**51-77 Quebec Avenue and 40-66 High Park Avenue -
Zoning By-law Amendment Application - Request for
Direction Report**

| Date: | February 5, 2014 |
| From: | Director, Community Planning, Etobicoke York District |
| Reference Number: | 13 101816 WET 13 OZ |

Attachment 1: Site Plan

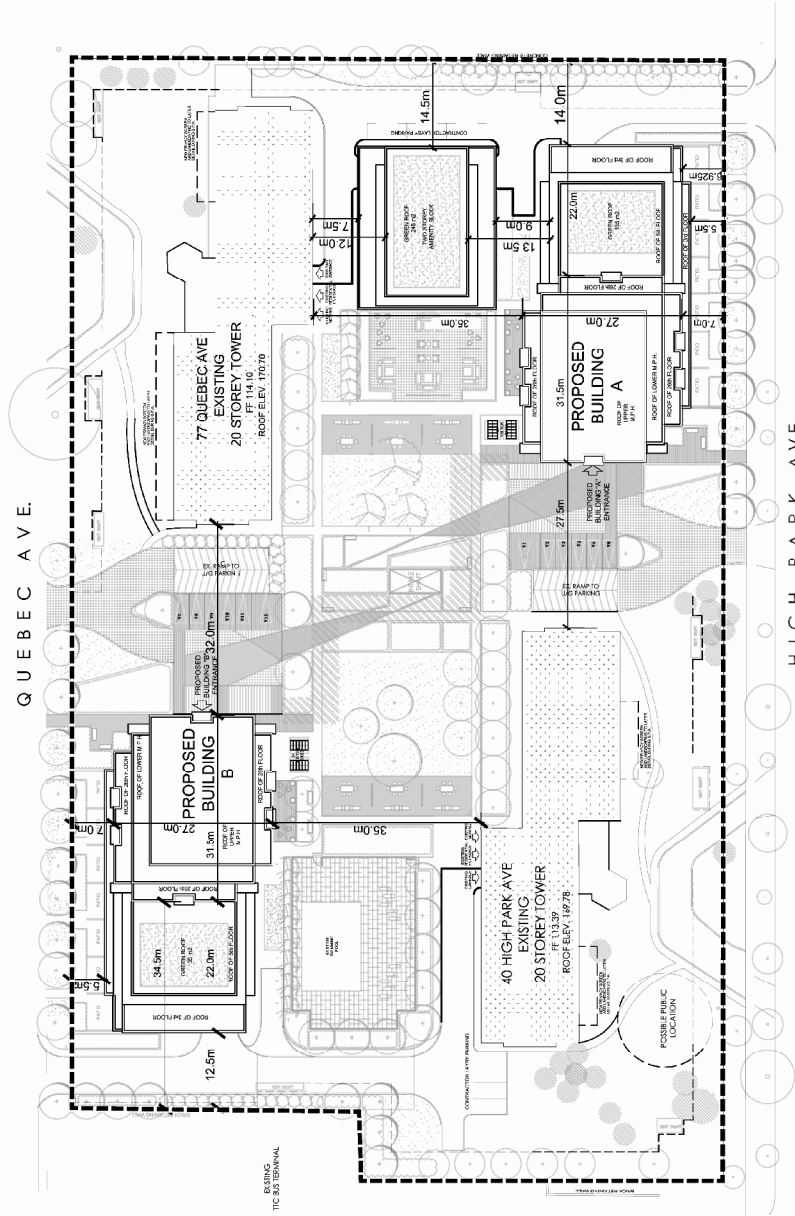
The proposed 2 storey amenity building would be located adjacent to the existing building at 77 Quebec Avenue and the ground floor of the amenity building would only be setback 7.5 m from the existing apartment building. The applicant has been requested to provide the floor plans of the existing building for staff to fully assess potential impact on the existing units in terms of light, view and privacy. The applicant has also been requested to provide additional details on the amenity building in terms of layout, programming, architecture and height, which at this time have not been provided.

Urban Forestry staff have advised the owner will be required to plant new 'large growing native shade' trees at a three to one ratio and that the current plans do not show enough new trees to satisfy the required plantings on private property.

The information noted on the data sheet portion of the plans submitted by the applicant note 401 bicycle parking spaces. However, the actual bicycle parking shown on the plans are as follows: 336 occupant parking spaces on P1 underground level for both buildings, 48 visitor spaces shown on the surface by the building entrances, for a total of 386 bicycle parking spaces. This represents a visitor bicycle parking shortfall of 36 spaces.

Attachment 2: North Elevation

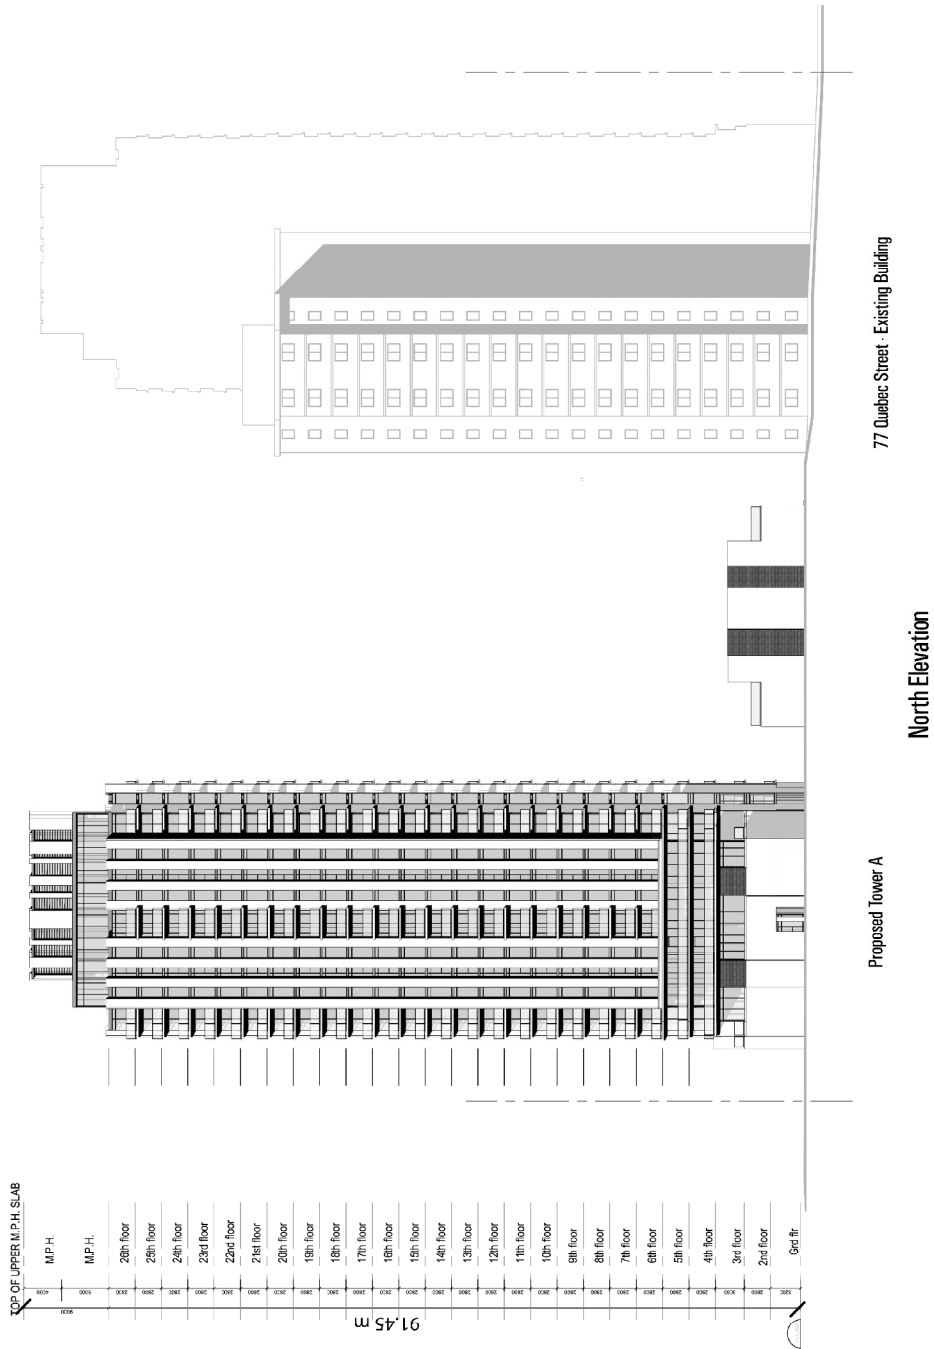
The revised proposal has increased the height of both base buildings from 3 storeys to 5 storeys. It is staff's opinion that the height of the base buildings should be reduced in order to respond to the context of their respective street and should be more in keeping with the scale and character of the existing built form along Quebec Avenue and High Park Avenue.

The proposed development does not respect or reinforce the existing built form character, streetscape and open space character of the area. The proposed building setbacks are not consistent with those established in the area and the height of the proposal is in excess of the existing context. Staff are of the opinion that the height of the proposed buildings should be reduced to be more consistent with the character of the block and the setbacks for the tower portion of the buildings should not extend closer to the street and should align with the abutting towers. The revised proposal does not address staff's concern with height, massing and shadow impacts. Staff are proposing to continue to work the applicant to develop a proposal which respects and reinforces the existing context. Staff will continue discussions to reduce the overall building heights, height of the base portion of the buildings, increase the setback of the tower portion of the buildings and improve the massing. Staff will also continue discussions aimed at minimizing the impact of the shadowing on the amenity area and providing appropriate transition to the lower scale development along Bloor Street West.
